DEVELOPMENT REVIEW BOARD
SUPPLEMENTAL SUBMITTAL

PROJECT NO. 2022-006547

DESCRIPTION: DRB - Site planning 2nd resubmittal city comments response

RE: Panda Express – S8-22-D8582
10126 Coors Blvd. NW
Albuquerque, NM 87114
RE: DRB Planning Review – 2nd Resubmittal
DRB Project Number: 2022-006547
App. Number: SI-2022-00216

NORTH-WEST ELEVATION 2
Scale= 3/16" - 1/0" A-202

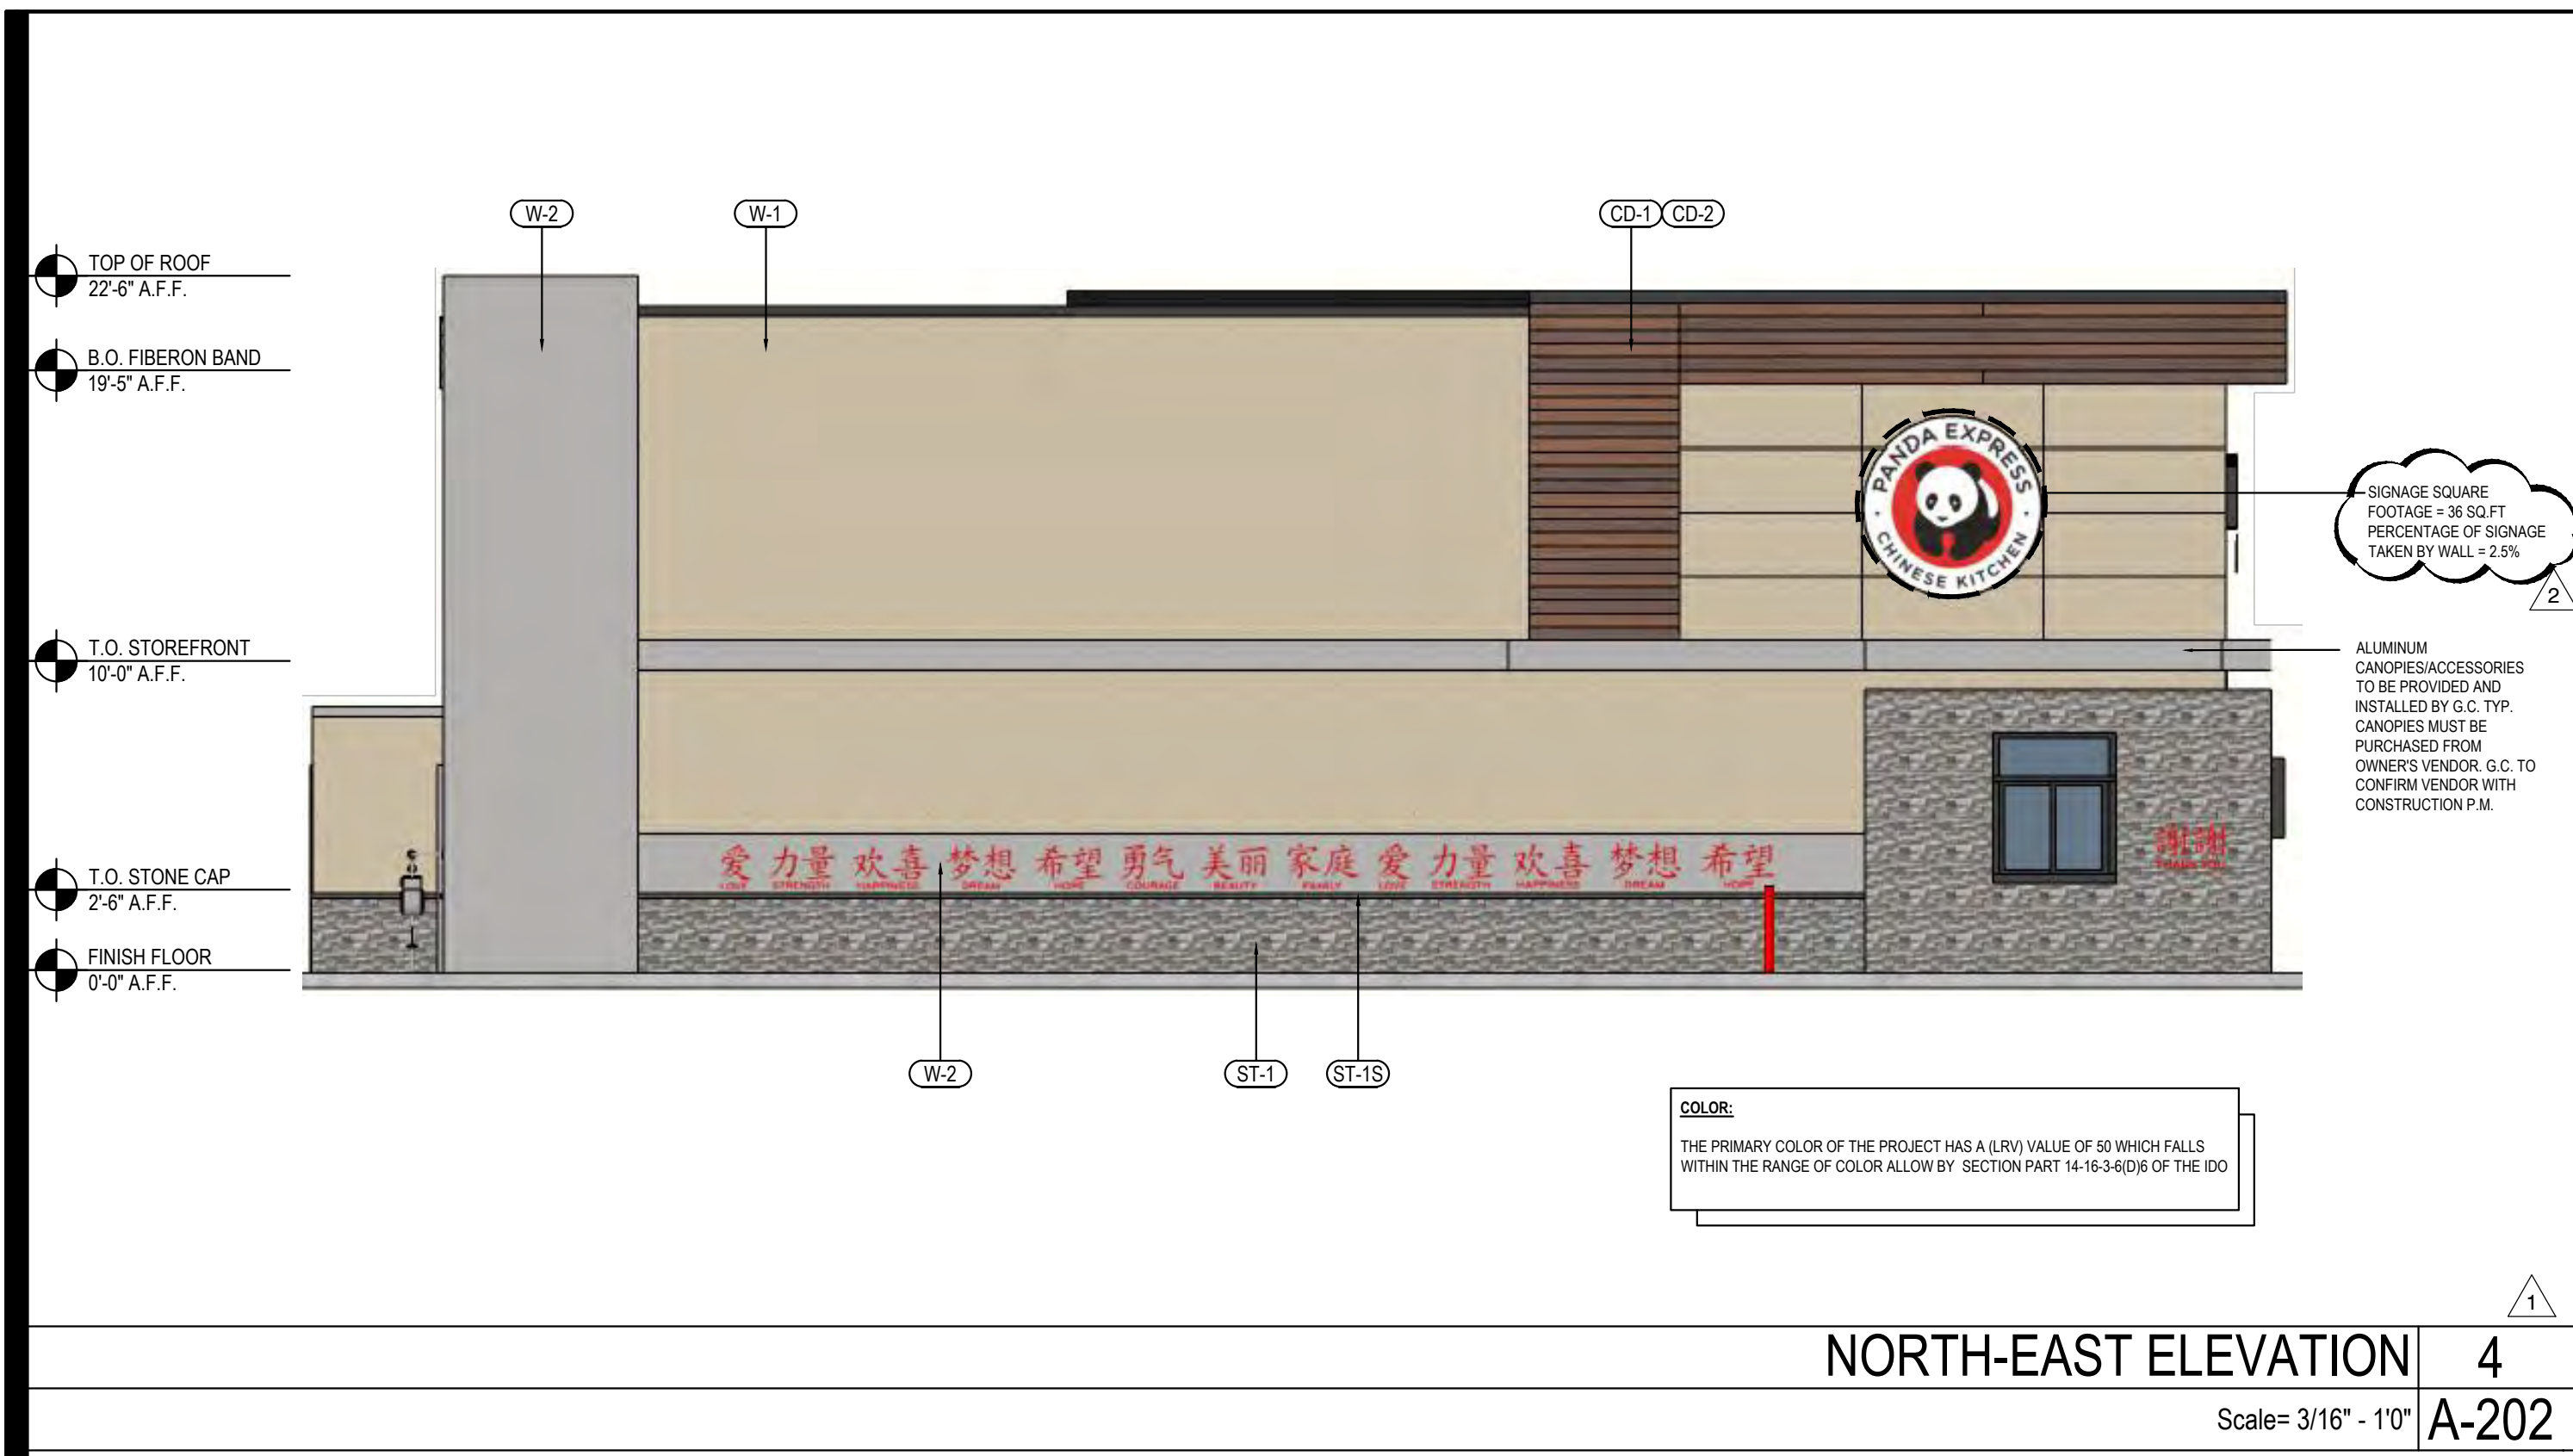
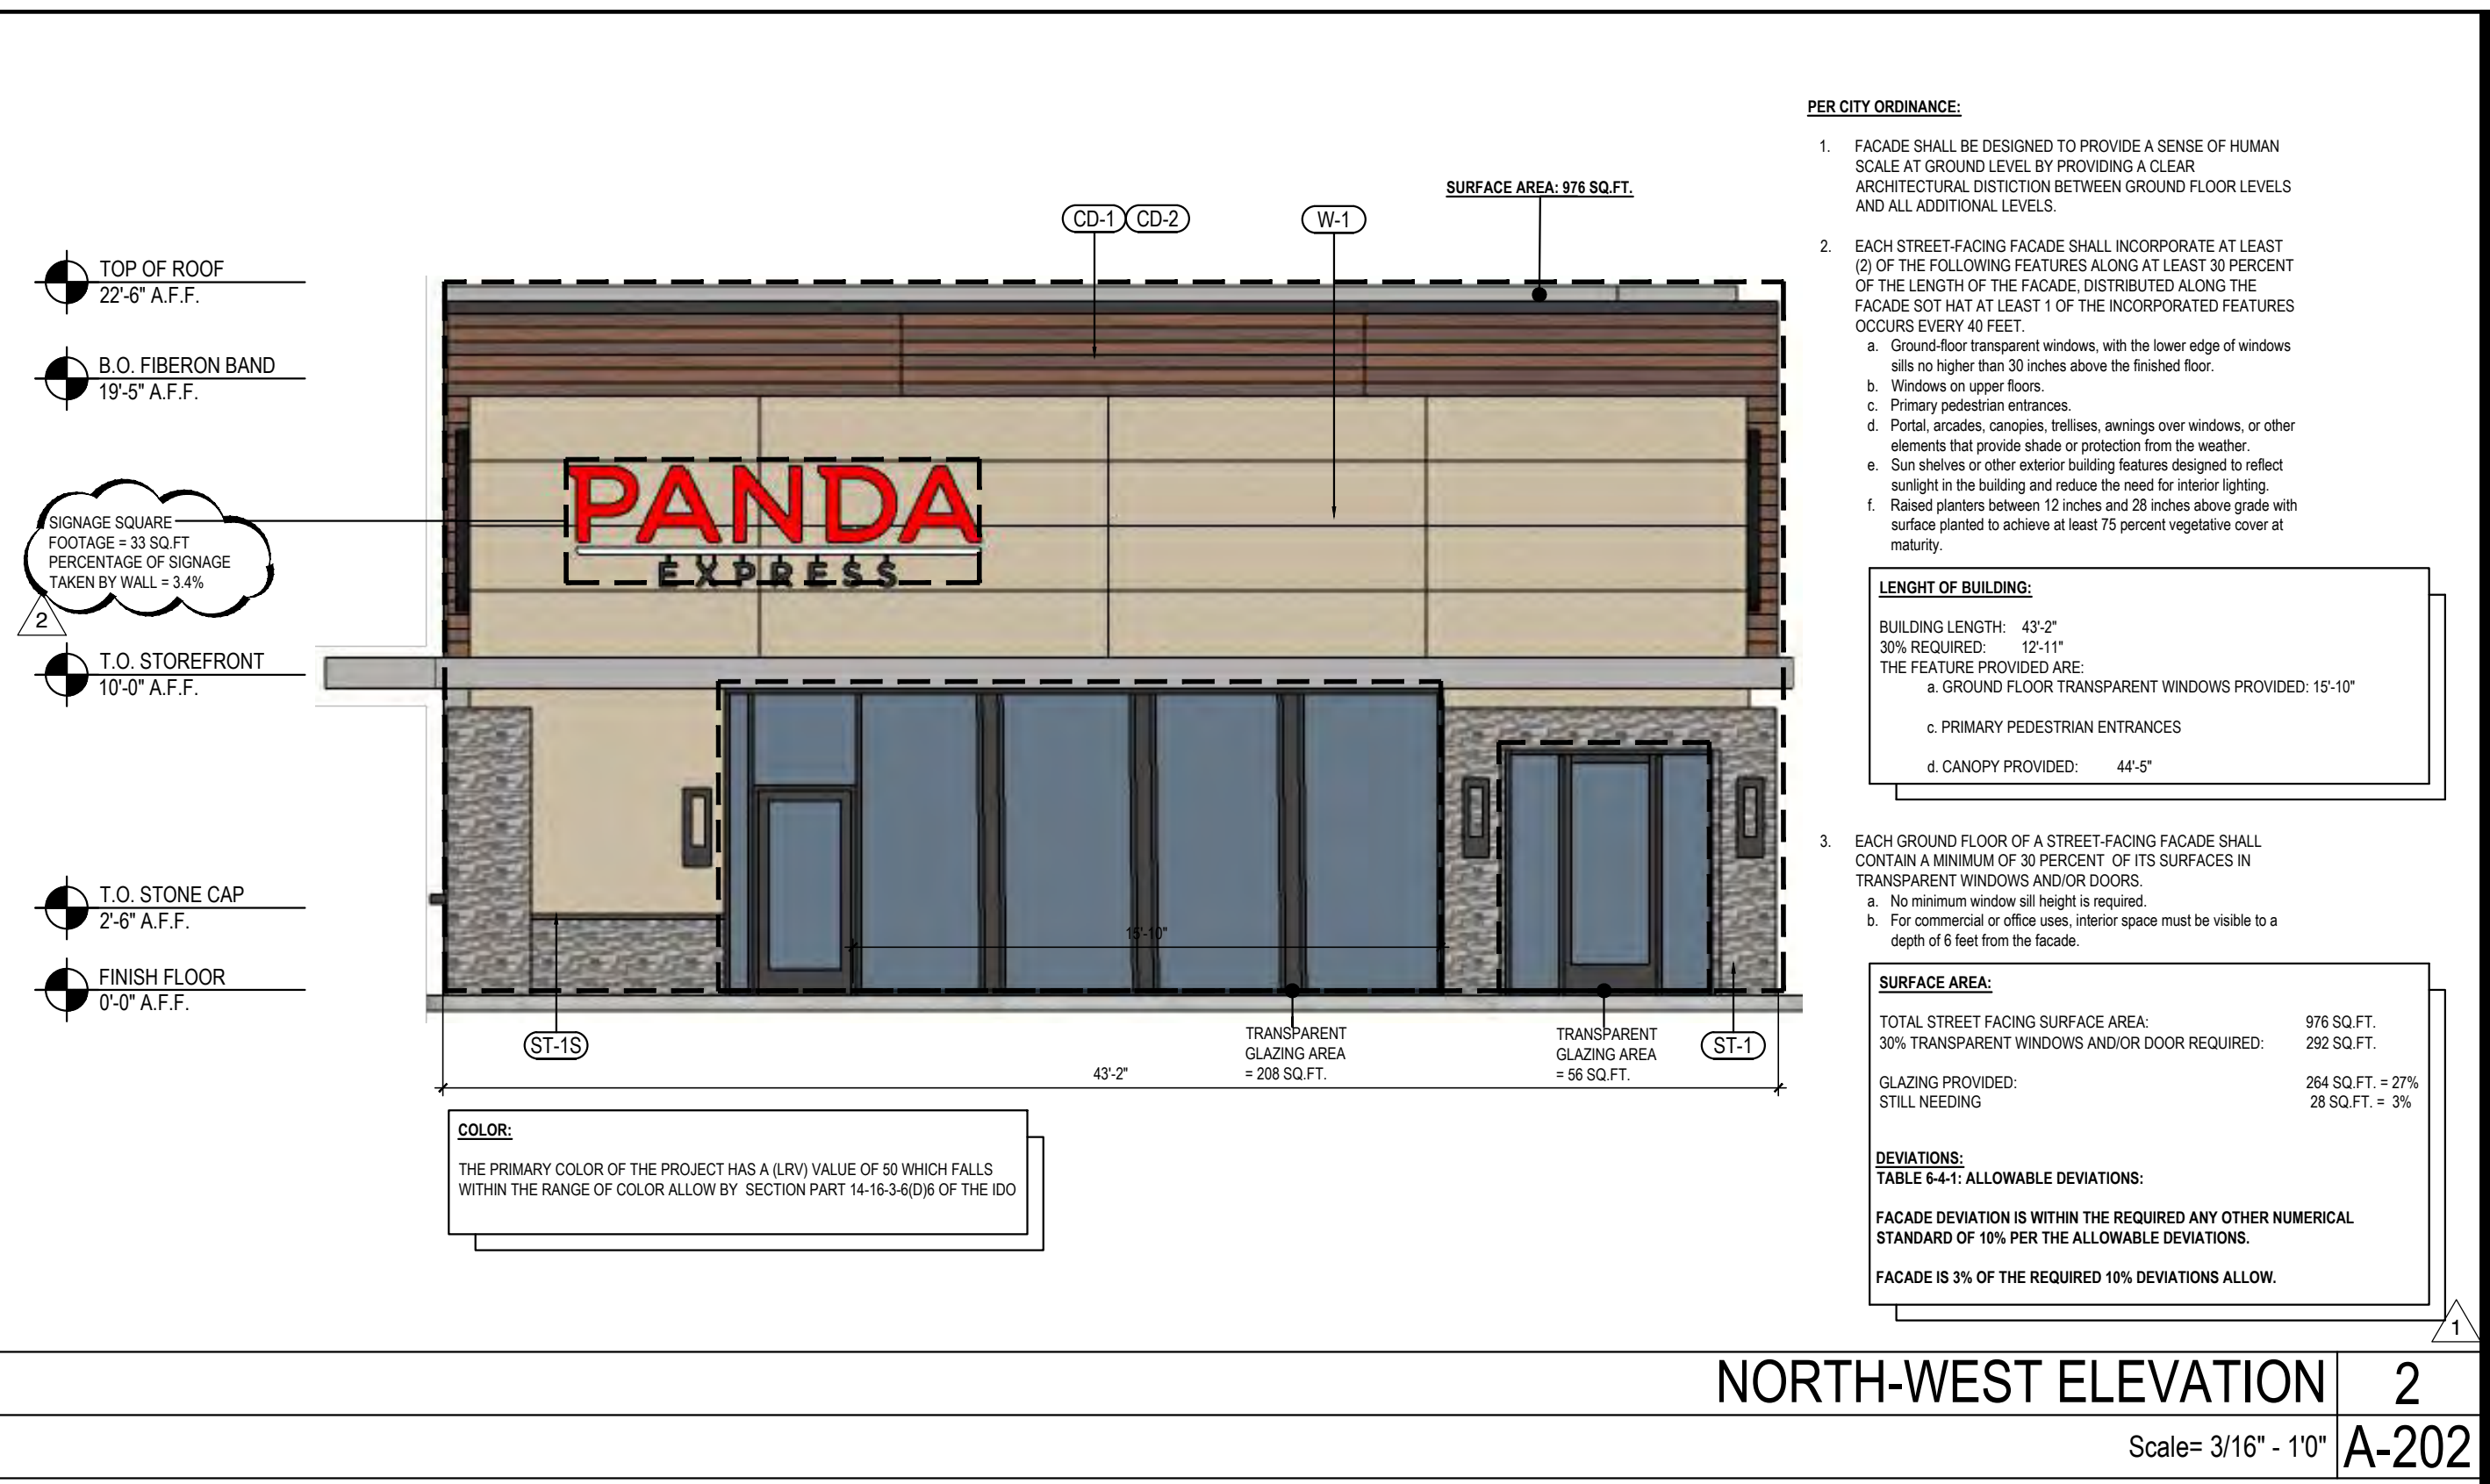
- The % of the façade taken up by the wall signage must be included.
Response: Refer to sheet A-202 for the percentage of façade the taken by the wall signage. See detail 2/A202 for the Northwest elevation signage is 3.4%, detail 4/A202 for Northeast elevation signage is 2.5% and detail 3/A-202 - Southwest elevation signage is 2.5%
